Access Compliance Report

Public Rights-of-Way (Curb Ramps)

Intersection ID: 50339	Main Street: CASTLECOVE_RD	Cross Street: PAISLEY_ABBEY_LN	Location: SE
ADA ID: 9EECEBF9C3FC	Ramp Type: Perp	Initial Pass/Fail: Fail	Overall Compliance: No
		Severity Score: 12.5

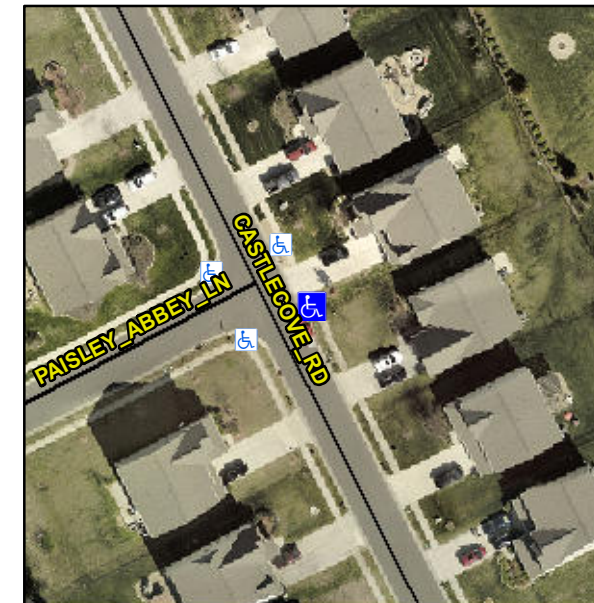
Not Found, R304.5.3

Compliance	Description	Data	Compliance	Description	Data
N/A	Ramp Length (in)	45.0	Yes	Ramp Slope (%)	6.0
Yes	Ramp Width (in)	48.0	No	Ramp XSlope (%)	5.3
N/A	Flare Type LT	N/A	N/A	Flare Type RT	N/A
N/A	Flare Slope LT (%)	N/A	N/A	Flare Slope RT (%)	N/A
N/A	Flare Traversable LT?	N/A	N/A	Flare Traversable RT?	N/A
N/A	Landing Length (in)	N/A	N/A	DWS Provided?	N/A
N/A	Landing Width (in)	N/A	N/A	DWS Contrast?	N/A
N/A	Landing Slope (%)	N/A	N/A	DWS Length (in)	N/A
N/A	Landing X Slope (%)	N/A	N/A	DWS Full Width?	N/A
N/A	Landing Curb? (Y/N)	N/A	N/A	DWS Offset (in)	N/A
N/A	Shared Landing?	N/A			
N/A	Gutter Ponding?	N/A	N/A	Gutter Slope (%)	N/A
N/A	Gutter Lip Ht (in)	N/A	N/A	Gutter X Slope (%)	N/A
N/A	Painted X Walk1?	No	N/A	Painted X Walk2?	N/A
	X Walk 1 Direction	To SW		X Walk 2 Direction	N/A
N/A	X Walk 1 Width (in)	N/A	N/A	X Walk 2 Width (in)	N/A
	X Walk 1 Slope (%)	2.8		X Walk 2 Slope (%)	N/A
	X Walk 1 X Slope (%)	4.9		X Walk 2 X Slope (%)	N/A

Remove & Replace Entire Ramp.
